# Allentown Cat Clinic Parking Lot Expansion

MAJOR PLAN 2023-102

Planning Commission, September 12, 2024

**SUBJECT:** Allentown Cat Clinic Parking Lot Expansion  
MAJOR PLAN 2023-102  
REQUEST FOR PRELIMINARY/FINAL PLAN REVIEW

PARKING LOT EXPANSION  
 SOUTH WHITEHALL TOWNSHIP, LEHIGH COUNTY, PENNSYLVANIA  
 FOR  
 ALLENTOWN CAT CLINIC, PC  
 EXISTING FEATURES & DEMOLITION PLAN

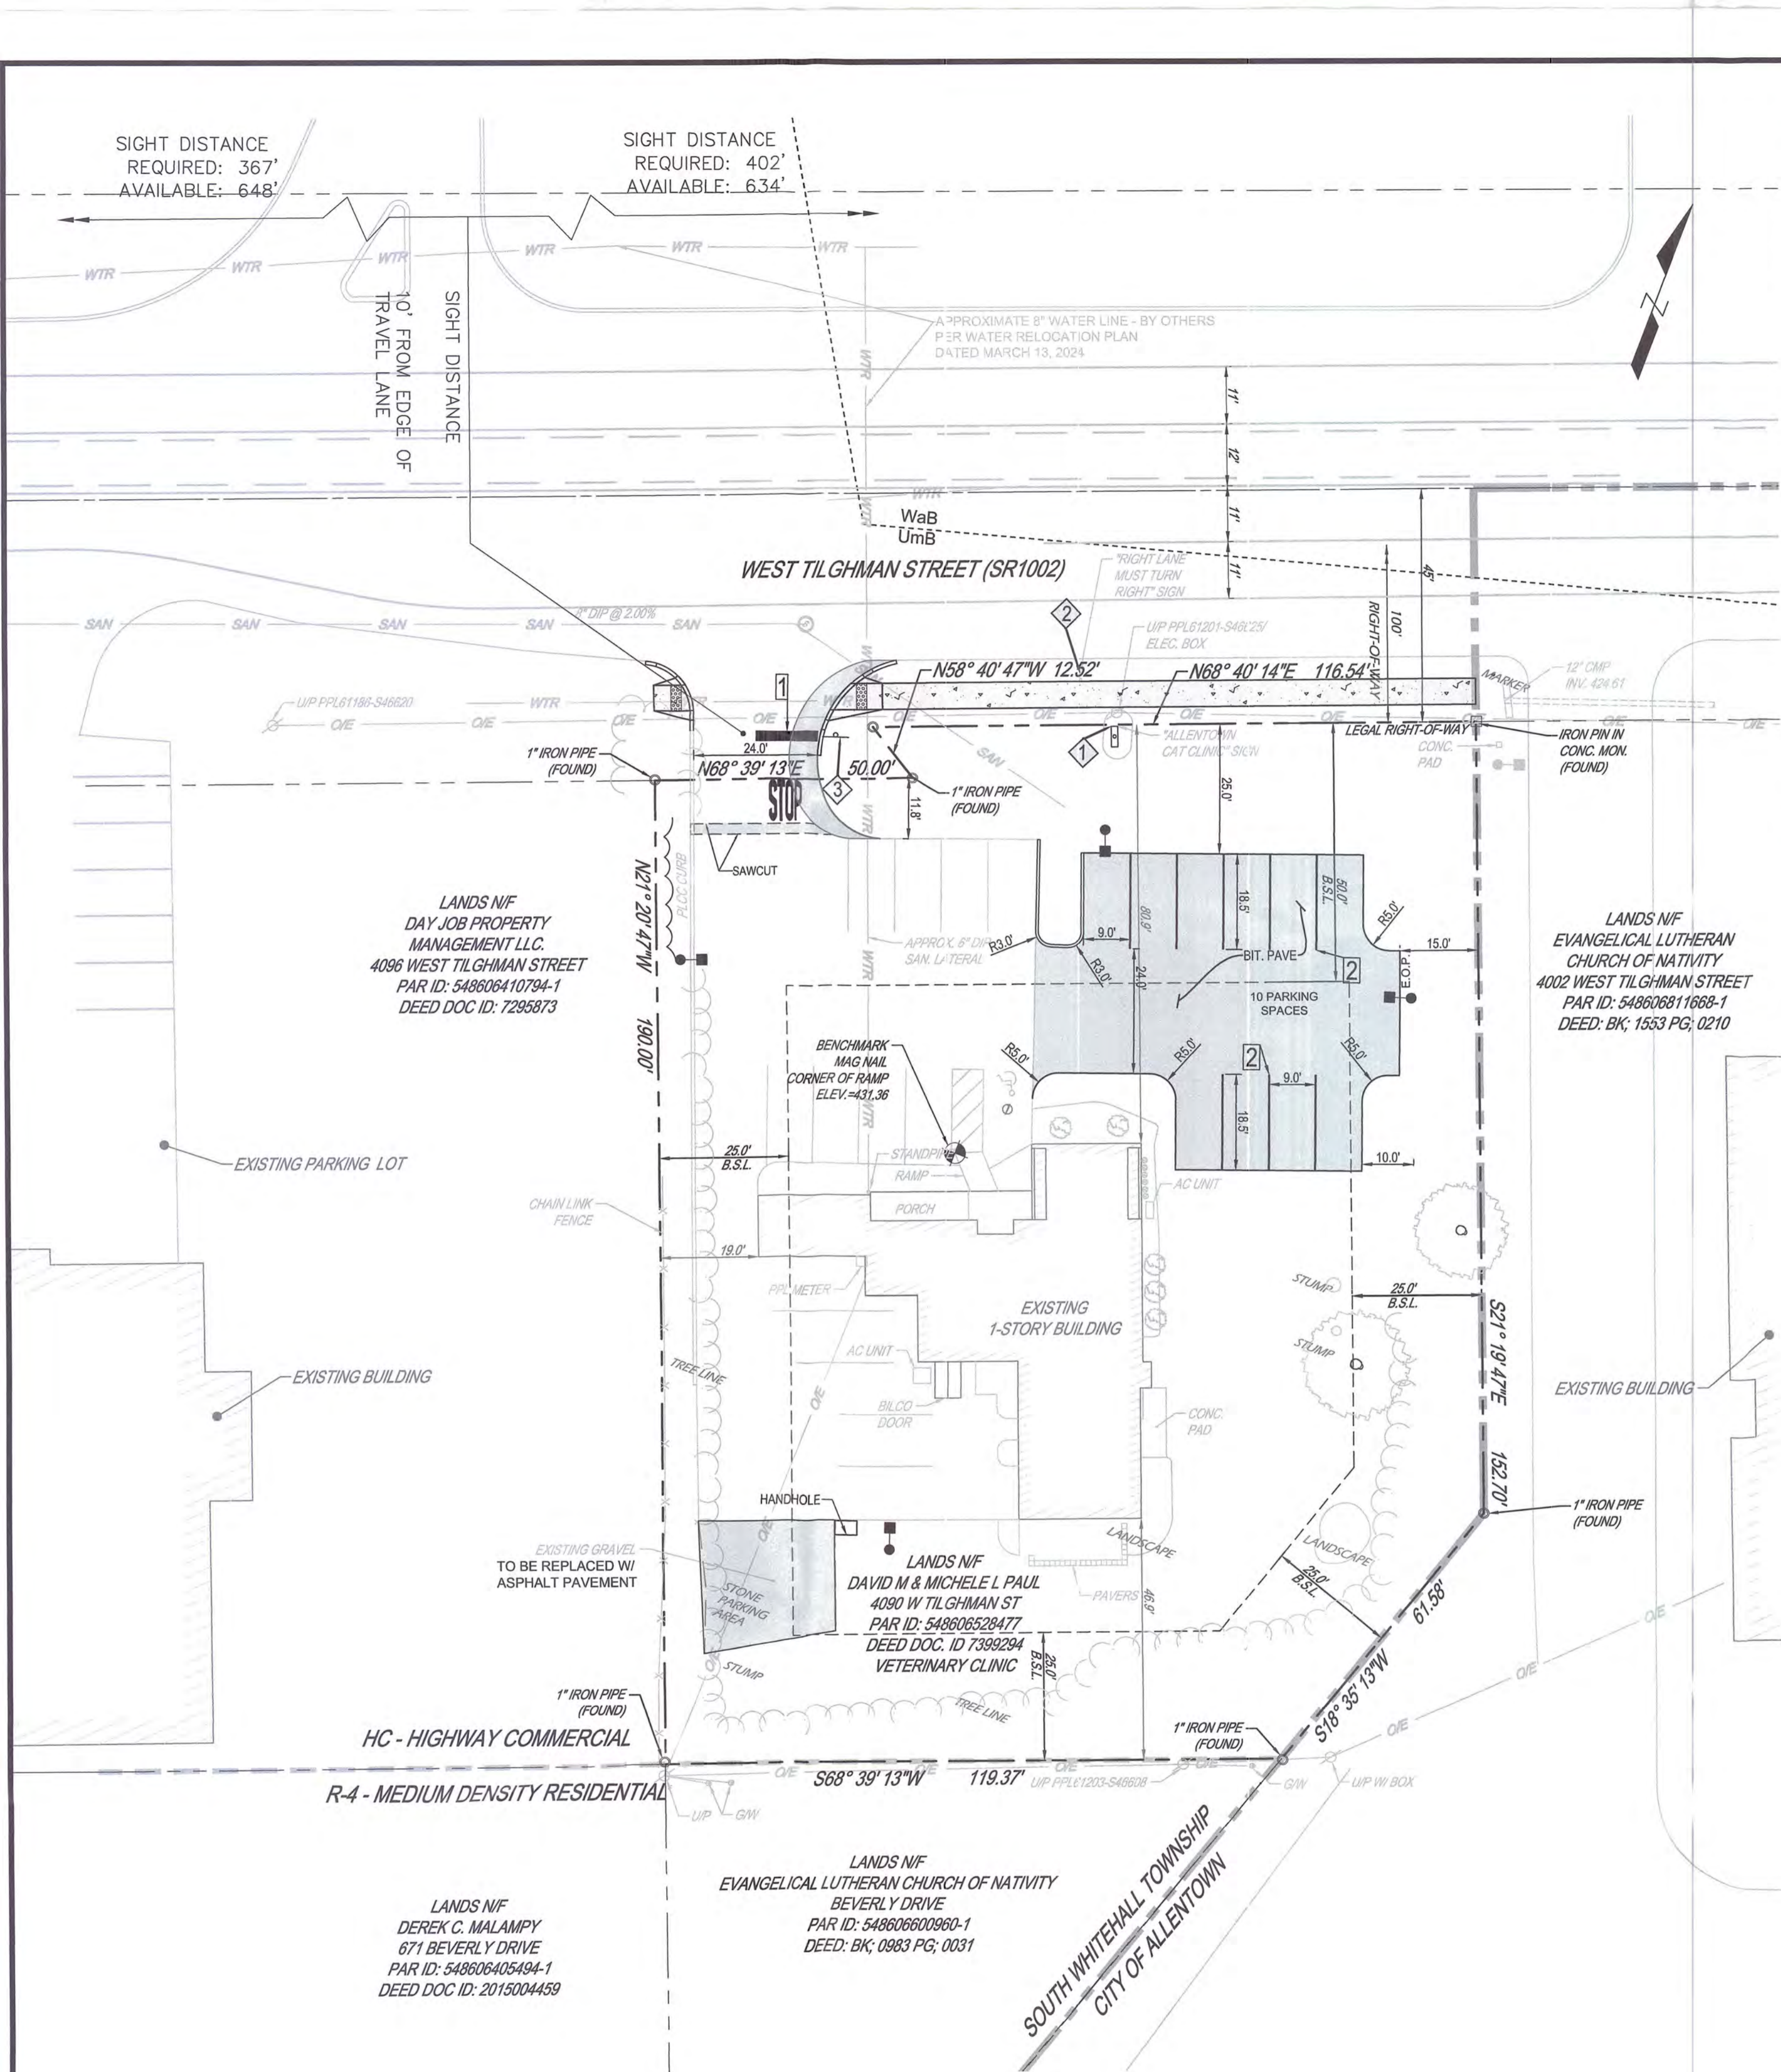
1. The Shade Tree Commission should determine the acceptability of the proposed landscaping, SALDO §312-12(b)(28) and §312-12(b)(36);
2. Provide a sign tabulation for existing and proposed signage;
3. Provide a north arrow on Sheet 2, SALDO §312-12(b)(11);
4. Show the proposed sanitary sewer connection on the Layout and Zoning Plan, SALDO §312-12(b)(34);
5. Provide a project narrative describing the proposal, SALDO §312-12(b)(40);
6. Dimension the proposed sidewalk on the Plans; and
7. Revise the eastern property line swale grading to provide a maximum side slope of 3 feet horizontal to 1 foot vertical, SALDO §312-35(b)(3)(A)(viii)(1)(B)(ii).

**PARKING LOT EXPANSION**  
 SOUTH WHITEHALL TOWNSHIP, LEHIGH COUNTY, PENNSYLVANIA  
 FOR  
**ALLENTOWN CAT CLINIC, PC**  
**LANDSCAPING PLAN**

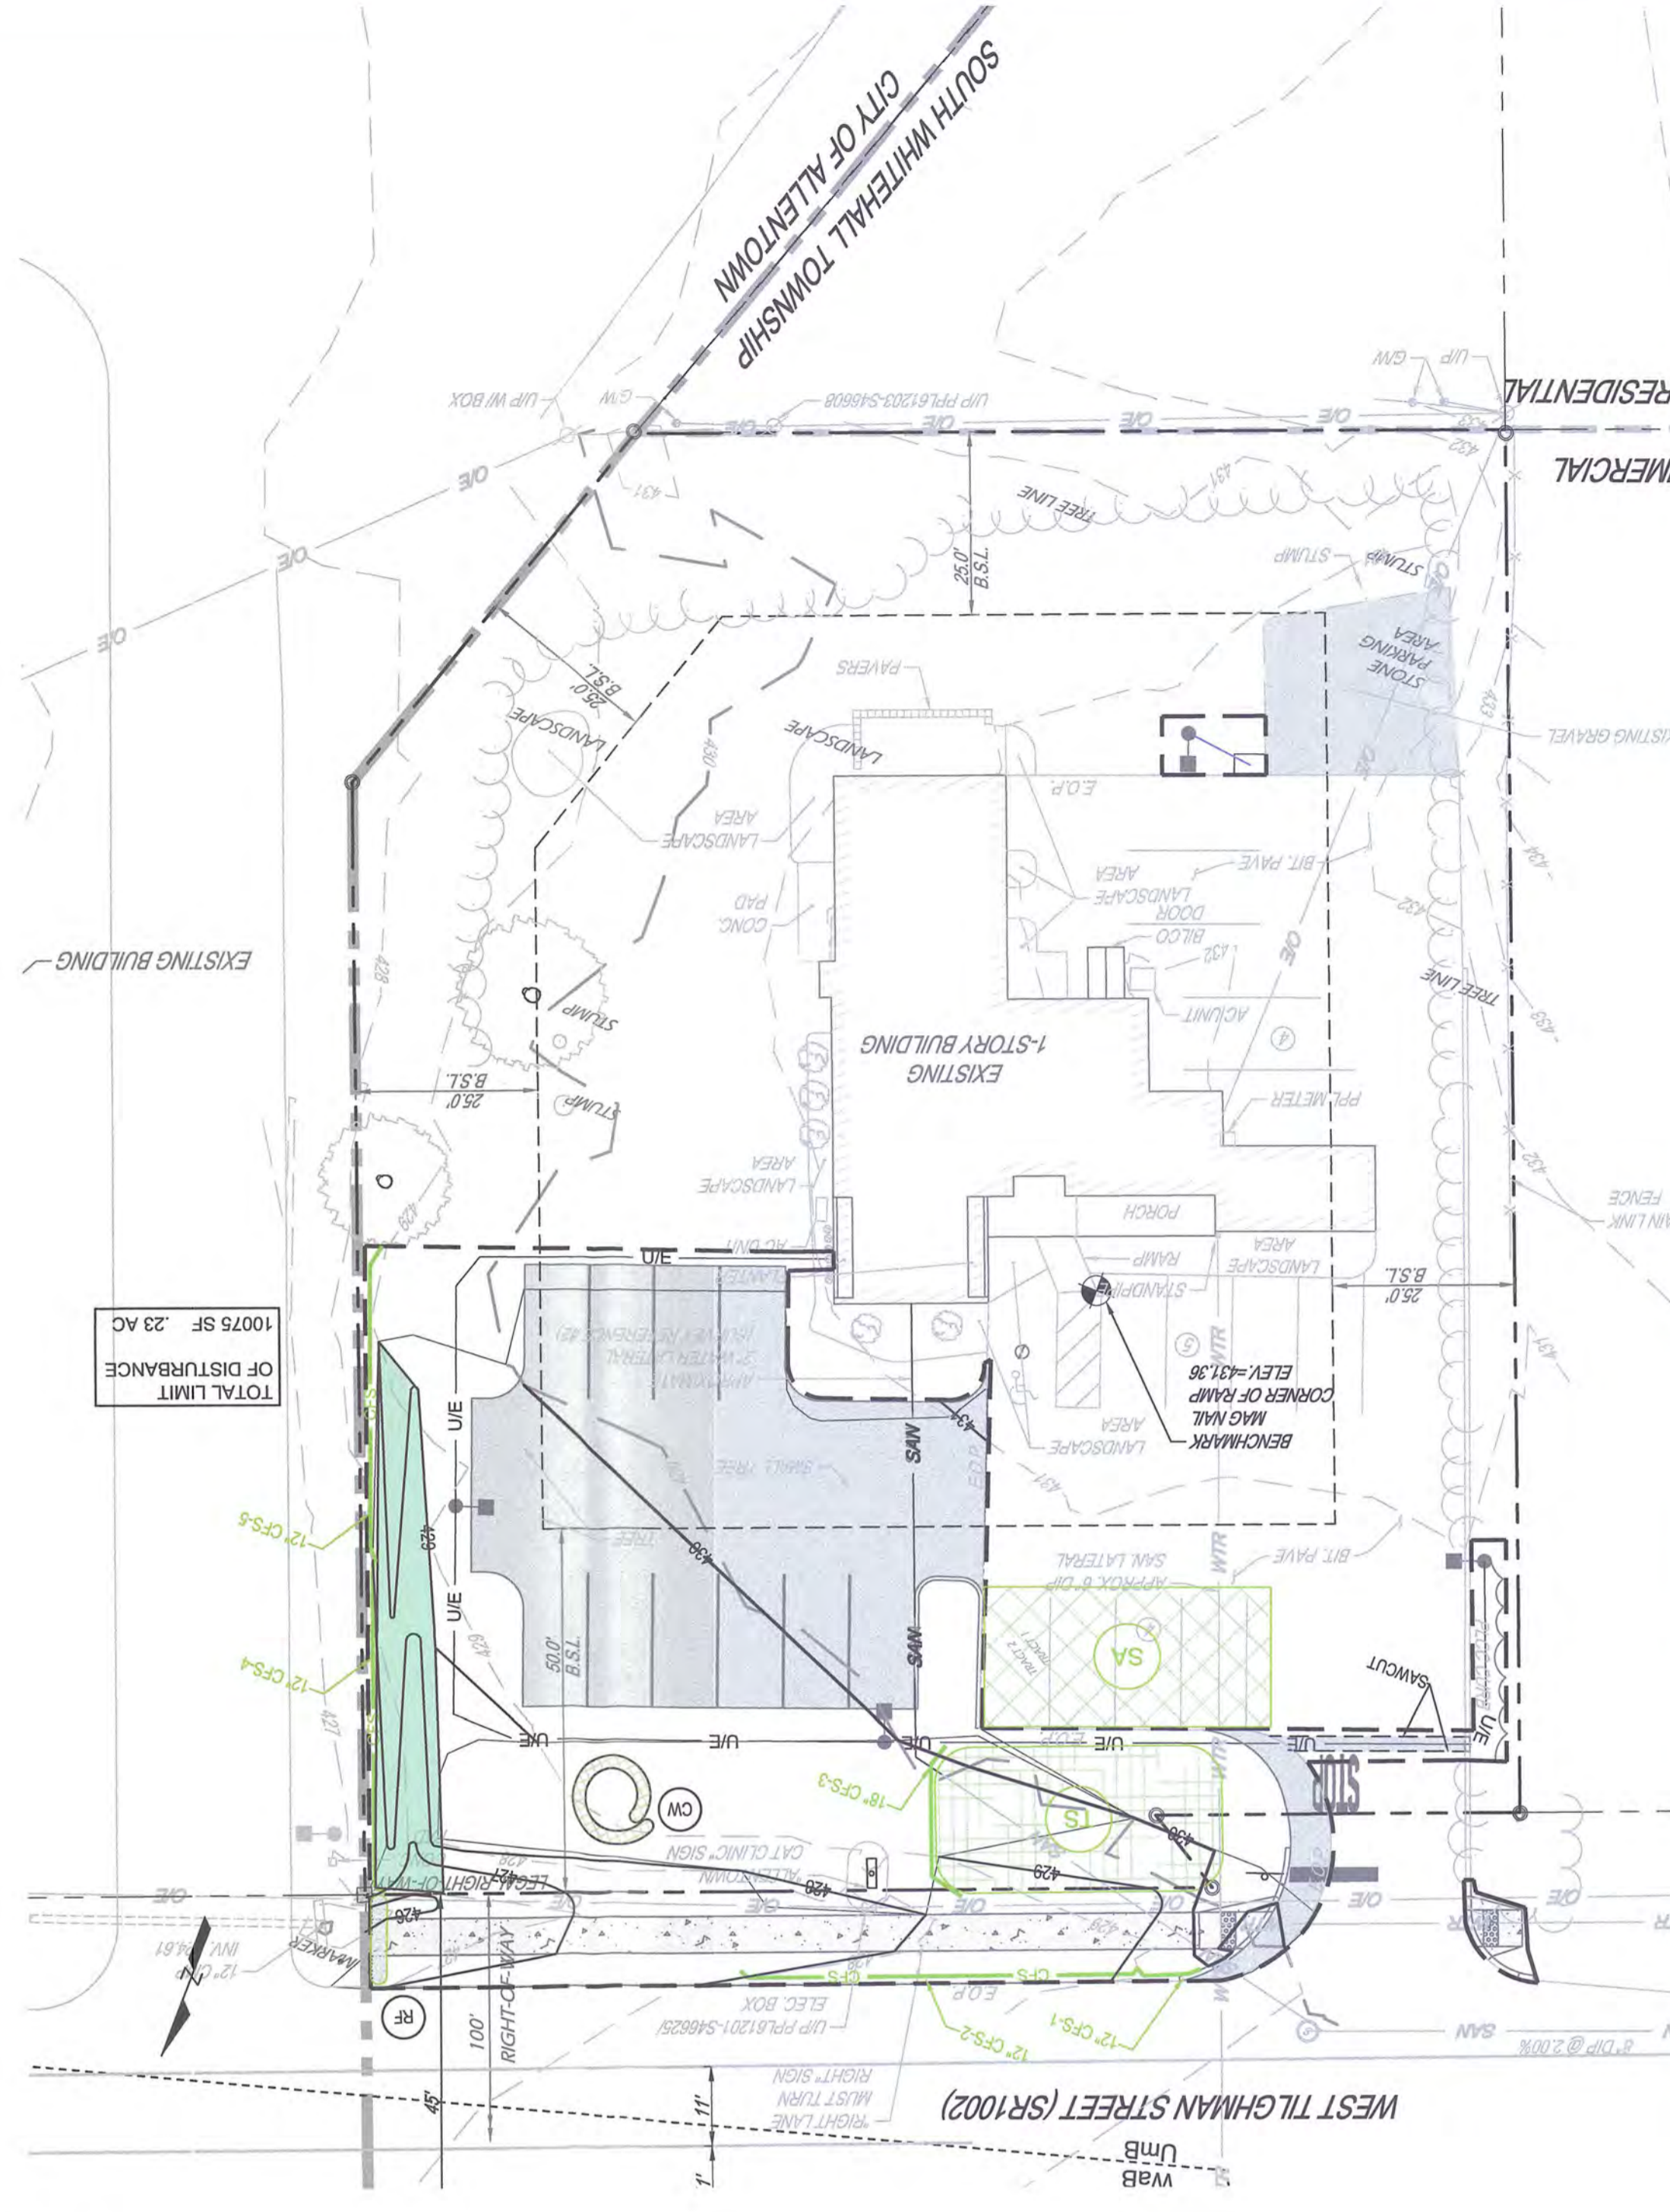
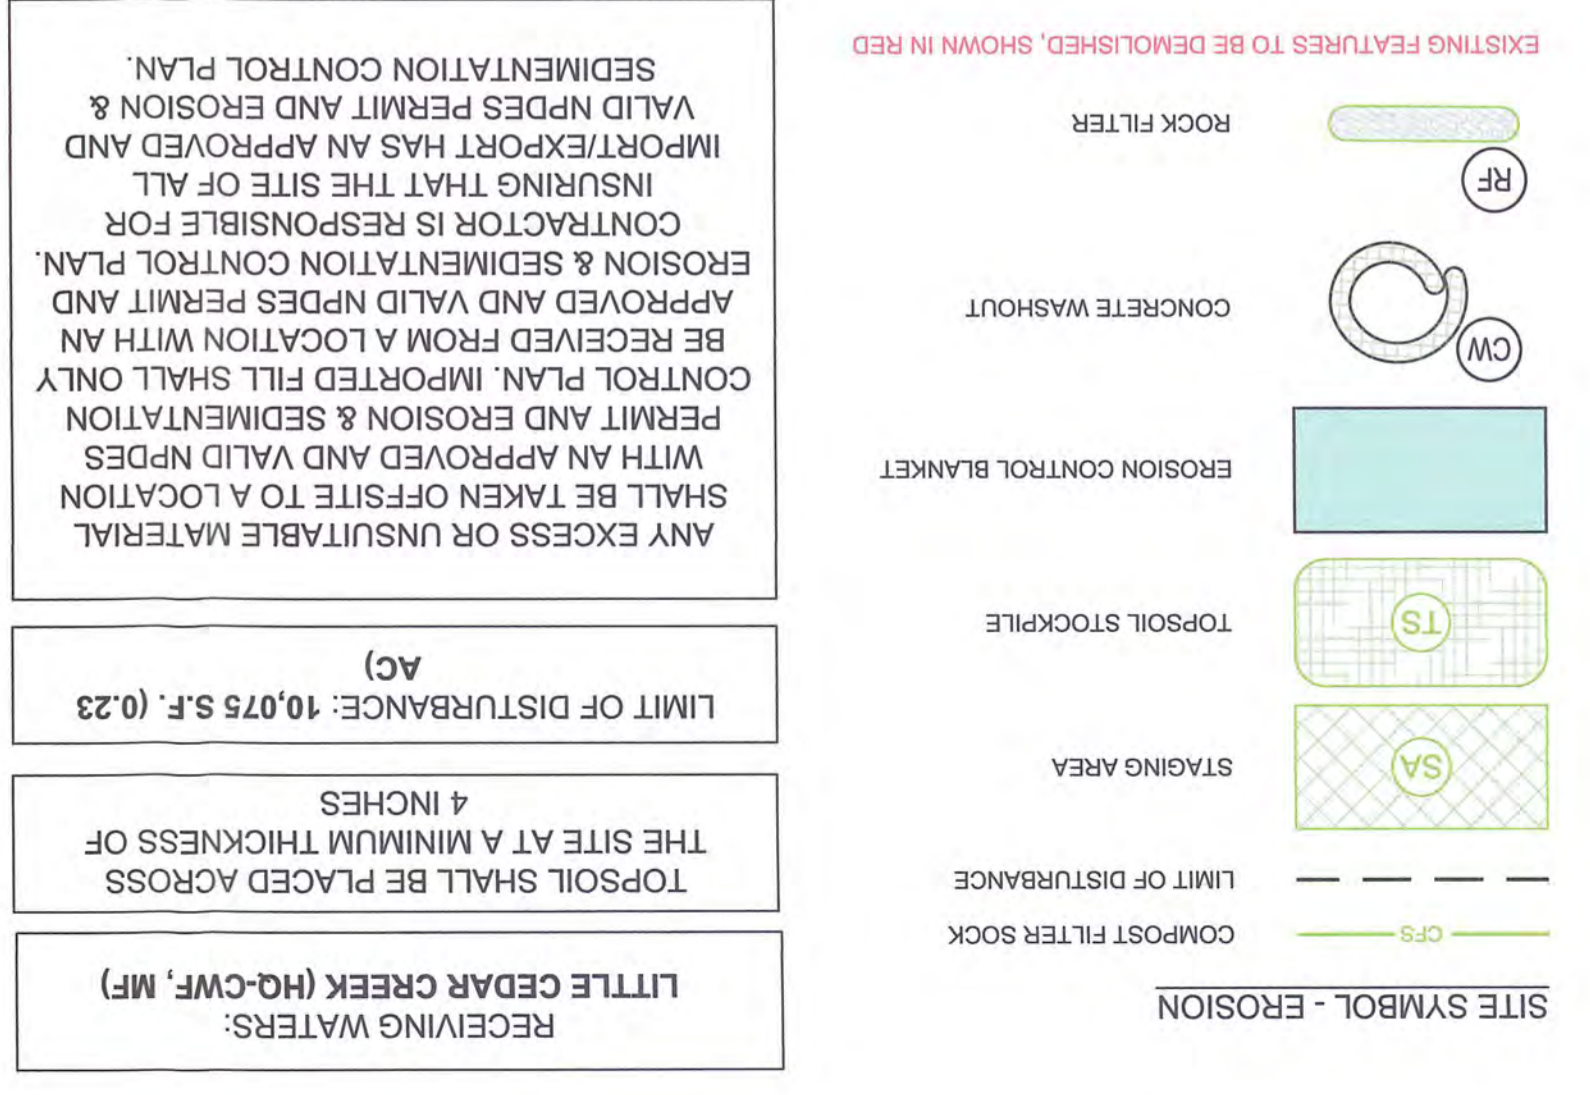
The Landscape and Shade Tree Commission requests that the landscape schedule include proposed plant sizes at installation in addition to the estimated mature size. The Commission also recommends the applicant consider replacing the *Azelea X Tradition (Azalea Traditional Pink)* with a more urban and sun-tolerant species of shrub. The Commission suggests that replacing the *Azelea X Tradition (Azalea Traditional Pink)* with additional *Thuja Occidentalis (Arborvitae Hetz Midget)* at smaller spacing would create a denser buffer between the parking lot and West Tilghman Street.
